ORIGINATION FORM

Proposed Revisions to a Standard Plans Index
(Please provide all information – Incomplete forms will be returned)

Index Number: **715-010**
Sheet Number (s): 3 of 3
Index Title: High Mast Lighting

HIGH MAST LIGHTING

INDEX	SHEET
715-010	3 of 6

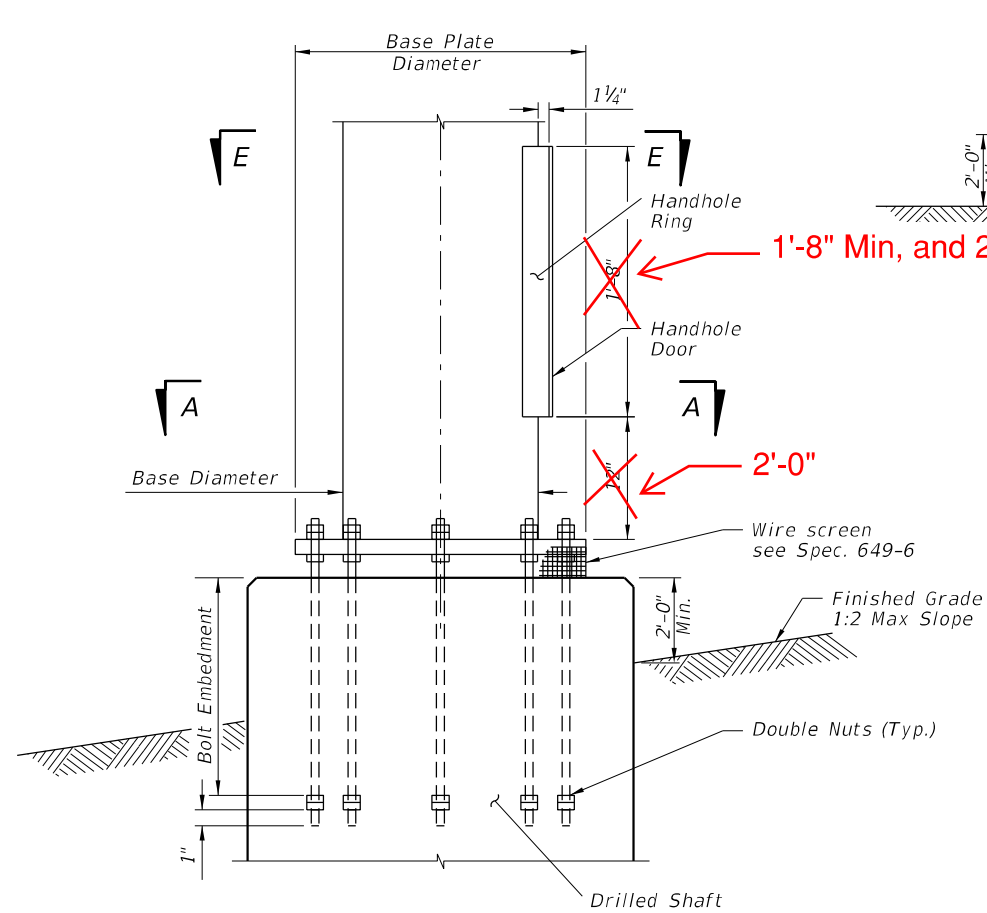
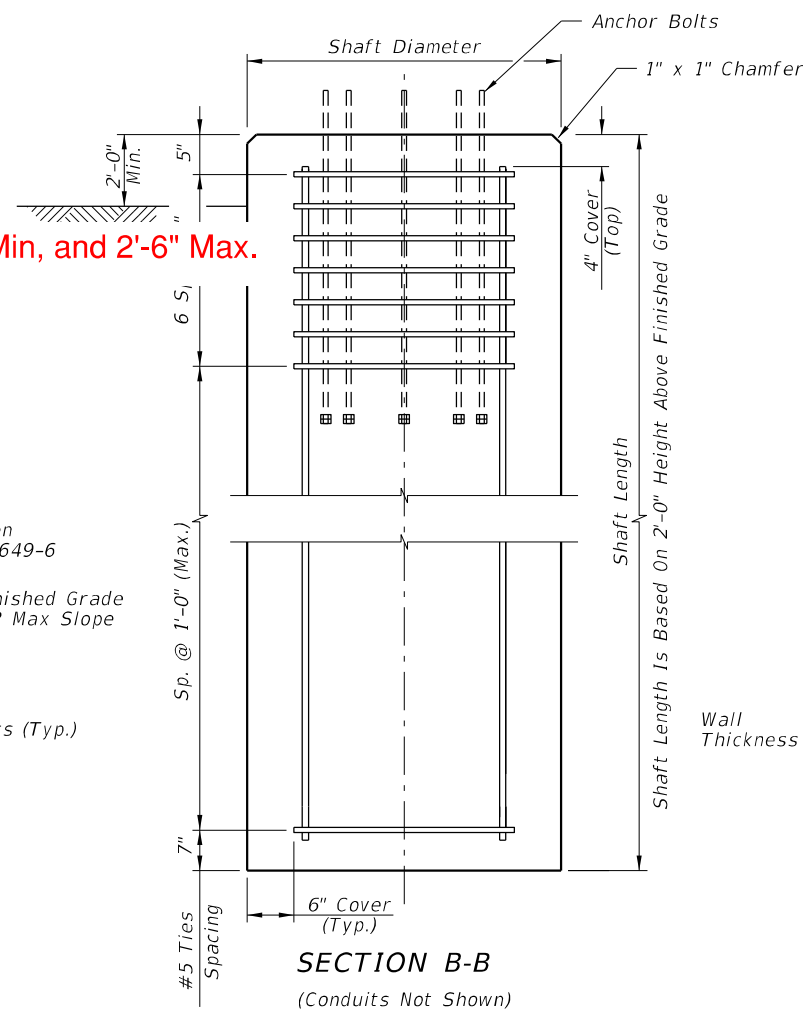
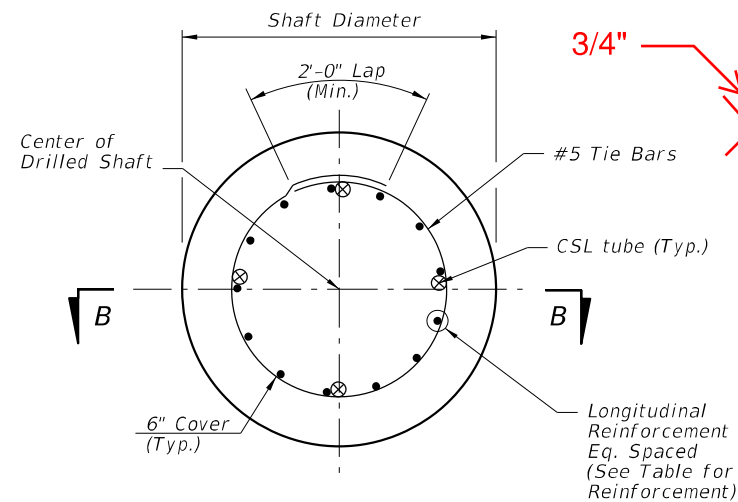
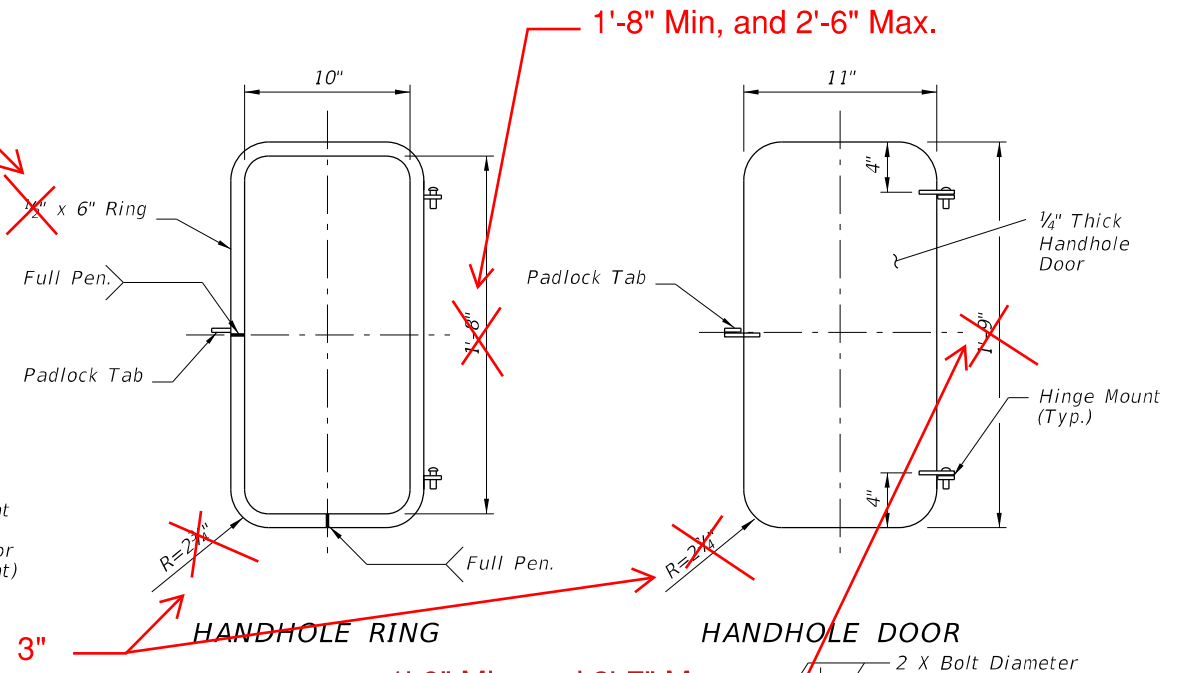
Sheet 3: Double dimension Handhole Ring and Handhole Door to allow variation in opening size; Changed dimension from top of baseplate to bottom of handhole.
